## MEMORANDUM

RE: PC 11 03 DR 01 Mills and Butler Round House

**RESOLUTION PC 11 03 DR 01**

## **EXHIBIT A: FINDINGS OF FACT FLORENCE PLANNING COMMISSION**

EXTERIOR ELEVATIONS

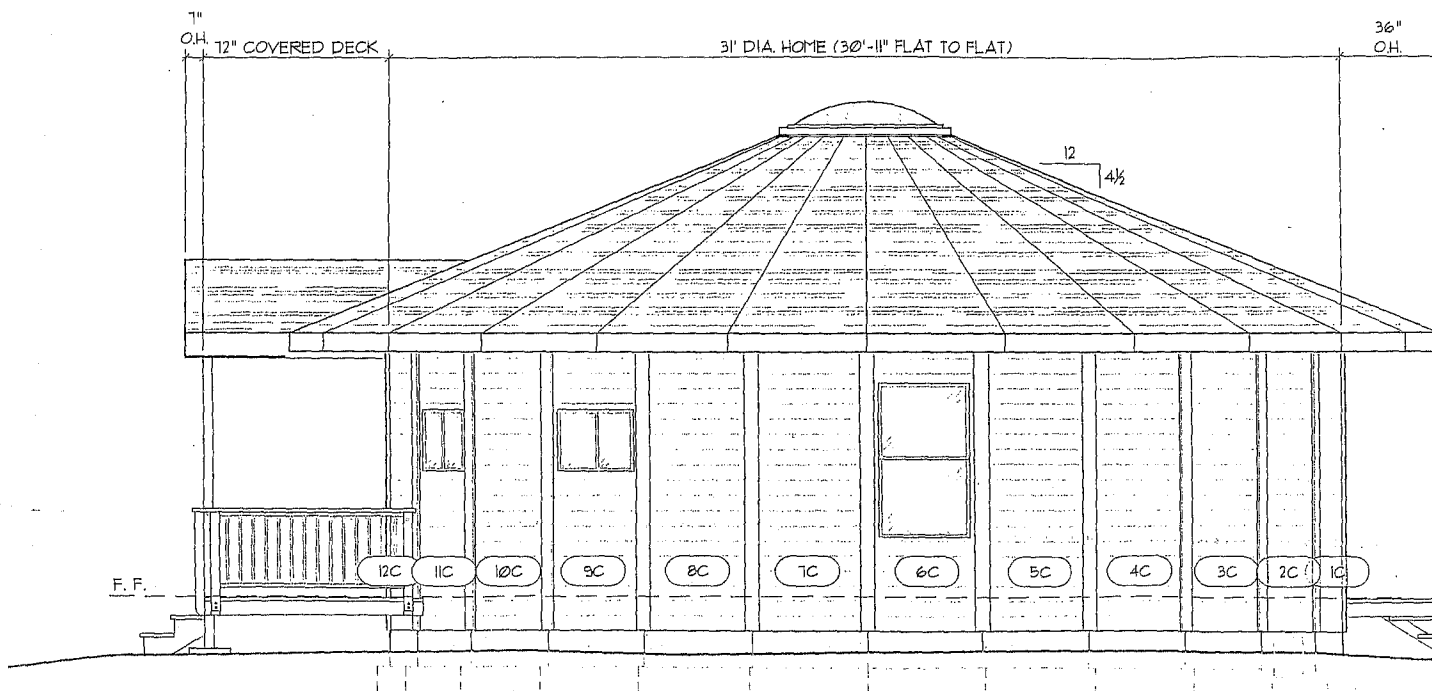
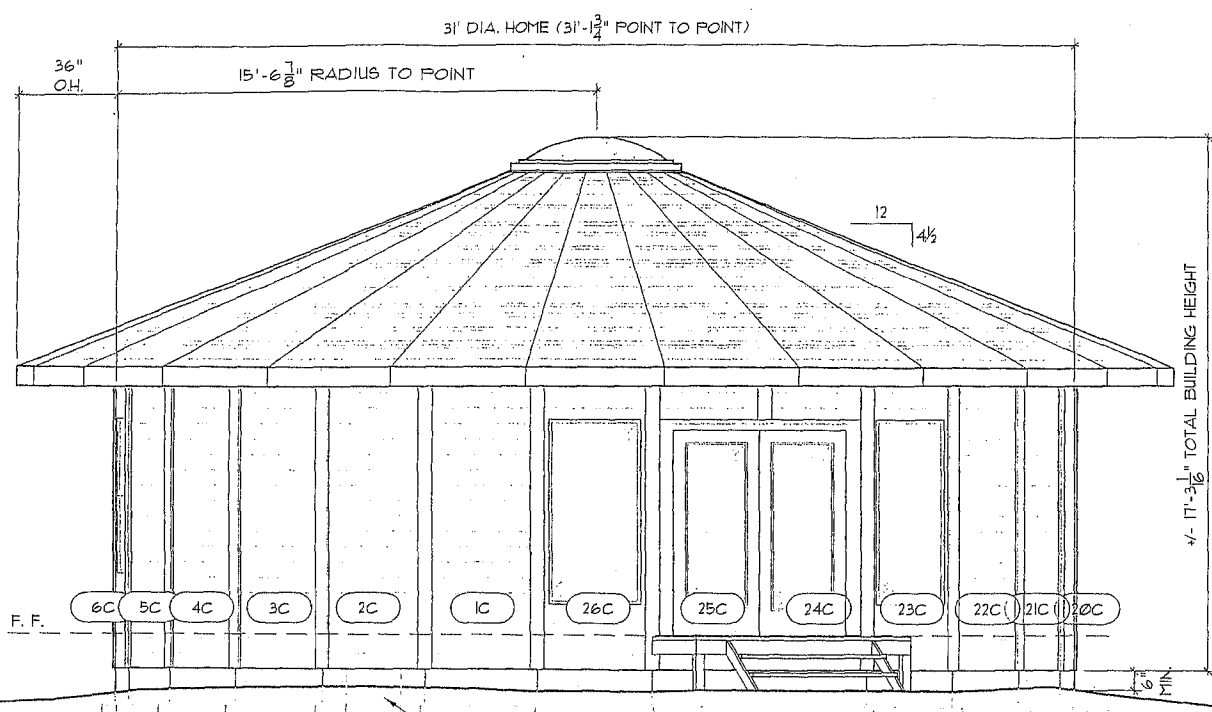
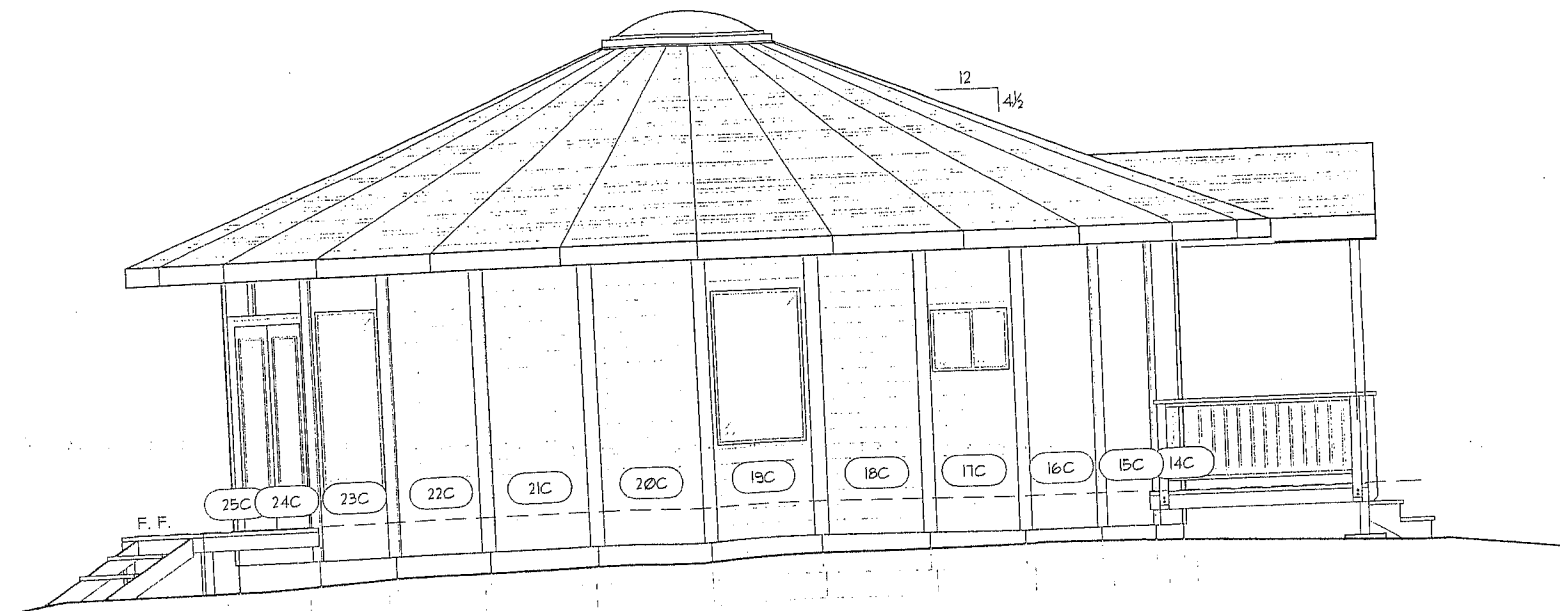
As they looked at the site with structural elements of the round house in place, the property owners liked the original design of the round house as submitted in Exhibit E with the small front porch as shown in the new conceptual drawing (see Exhibit L). The small front porch is similar in scale as the porch located north of the site.

The property owners are proposing a round house. The elevations in Exhibit E show the standard design of the round house. The front porch creates architectural qualities that is consistent with other nearby buildings.

The findings of fact incorporate approval of the round house façade design as shown in Exhibit E and L and the requiring the gate to not impede on the driveway's two parking spaces or required vision clearance area.

Exhibit G

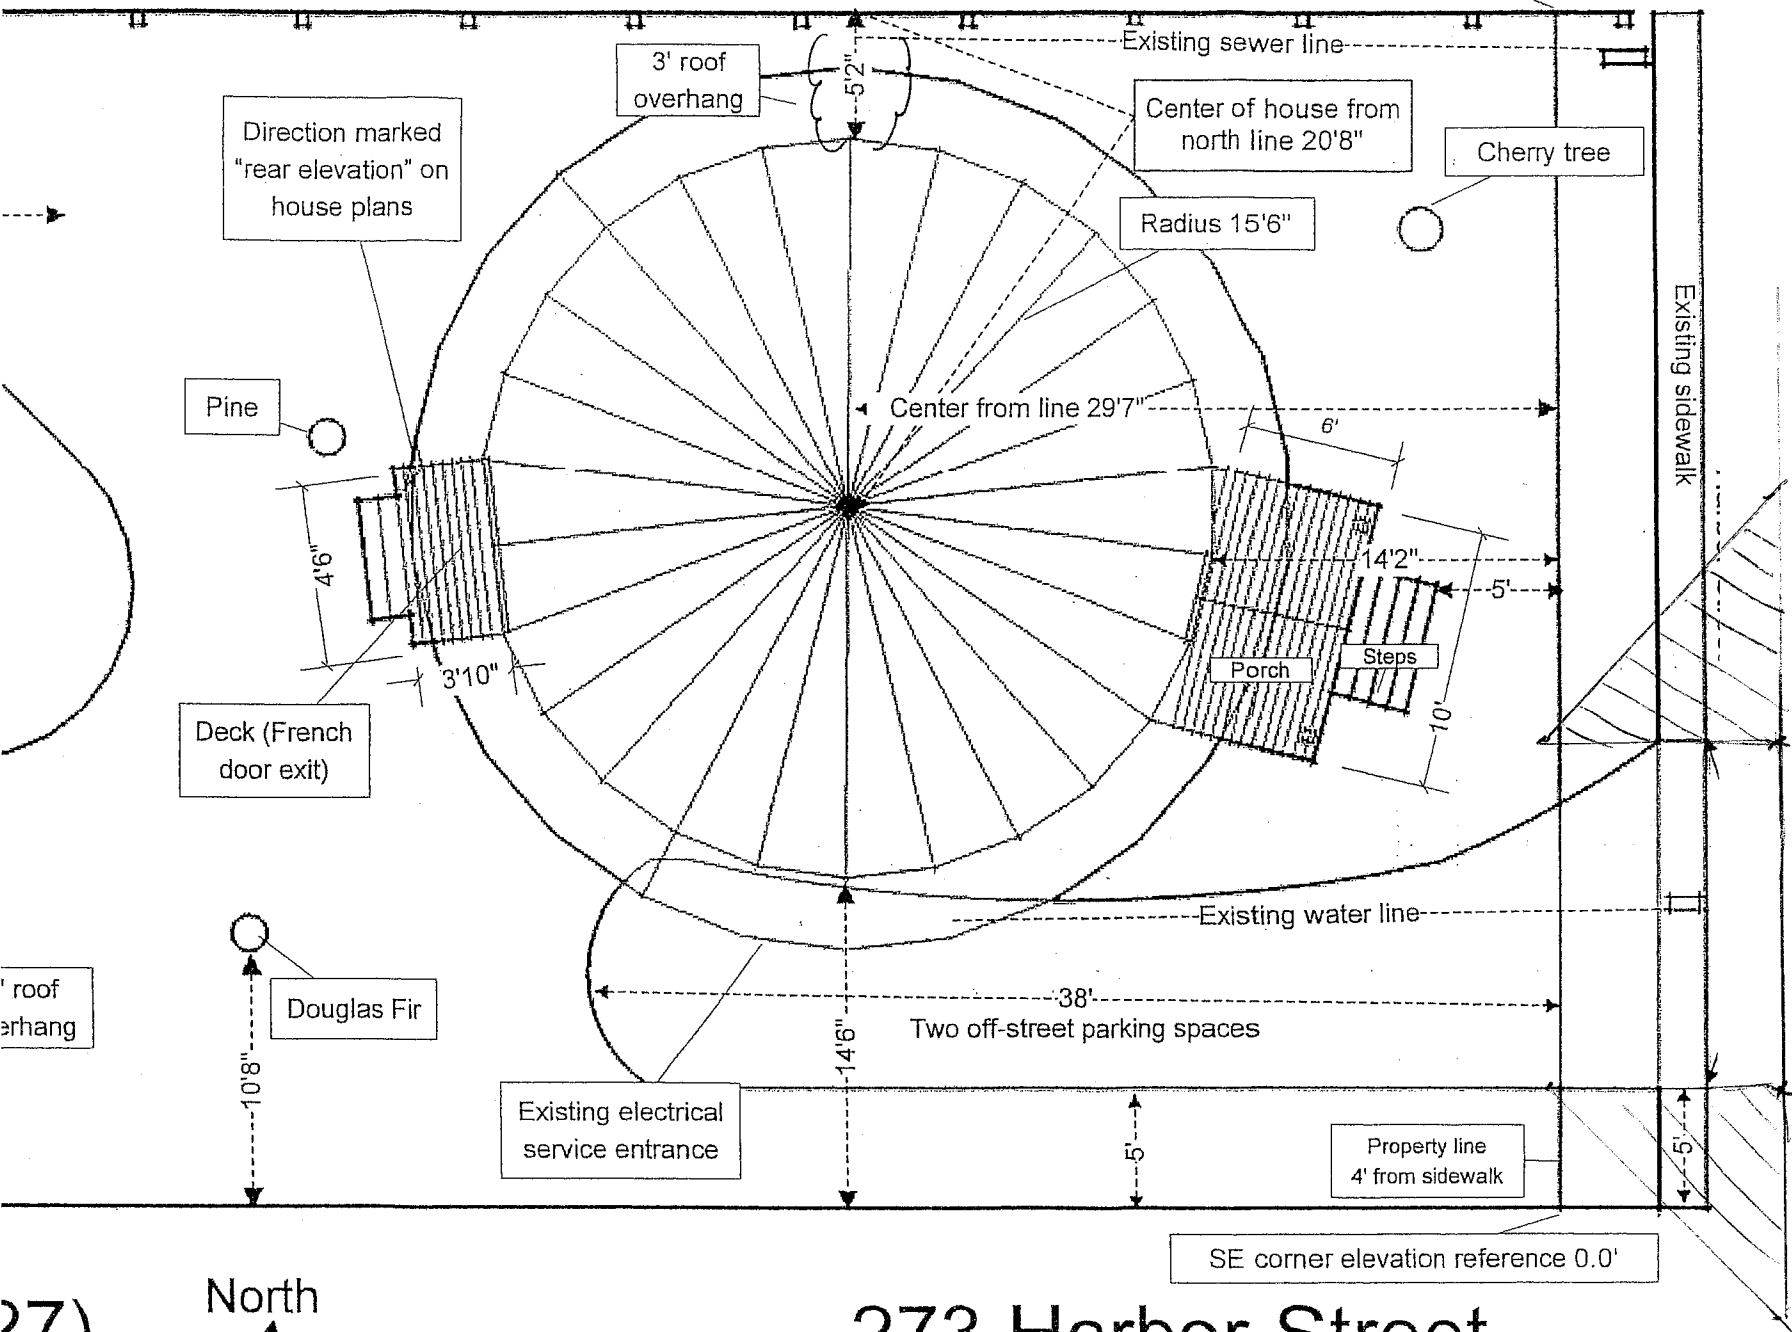
The applicants propose to use the existing driveway off of Harbor Street, which requires vision clearance areas that are ten feet by ten feet on each side of the driveway from edge of pavement or curb cut. The applicants propose a board and batten planter with an unspecified height within the right-of-way. The plants may be up to 2 ½ feet in height within the vision clearance area. As shown in the revised landscaping plan, the planters are not within the vision clearance area. The updated façade drawing shows a gate to be located to the south of the house. The gate shall not be within the vision clearance area. **(Condition 4 and 5)**

4. The gate and fence proposed to be located on the south side of the building, shall not infringe on the two parking spaces, public right-of-way or vision clearance area criterion and meet the height requirements of FCC 10-34-5-B-1.

5. There shall not be any plants or building materials over 2.5 feet tall within the vision clearance areas.
6. At least one trash receptacle shall be provided on site and all receptacles shall be screened in accordance with the 5' fence and wall height criteria.

Exhibit J

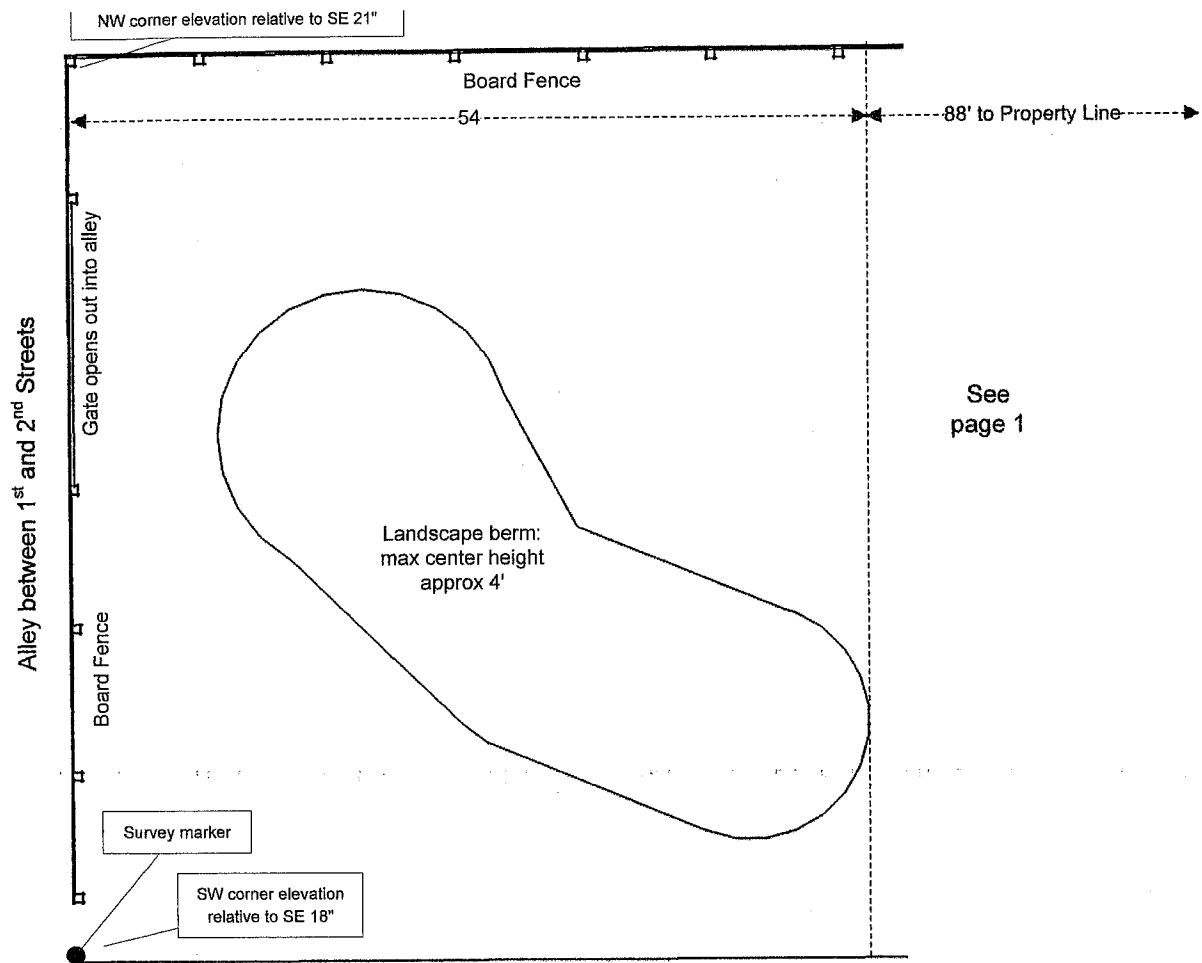
The proposed location of the building meets this 5' side yard criterion. The property owners are proposing side yard setbacks of 14.6 feet on the south and 5 feet two inches on the north. FCC 10-3-8-1 states that required parking spaces are not allowed within the front or side yards. The property owners are proposing two tandem off-street parking spaces. Both spaces access off of Harbor Street totaling 38 feet in length. Both spaces are shown on the site plan to be out of the side yard setback. However, the eastern space is shown to be within the front setback. The driveway shall be extended five feet to keep the parking spaces outside of the front setback or 43 feet long. **(Condition 3)**

As covered in the Old Town District section of this report, the site plan needs to be modified to meet the parking setback requirements. The parking spaces off of Harbor Street are required to be located outside of the 5' front yard setback (**See Condition 3**)

3. Prior to certificate of occupancy, the property owners shall ensure that the driveway is 43 feet long from the front property line. The driveway shall consist durable, dust free surfacing of asphaltic concrete, cement concrete, porous concrete or approved by the Public Works Director.
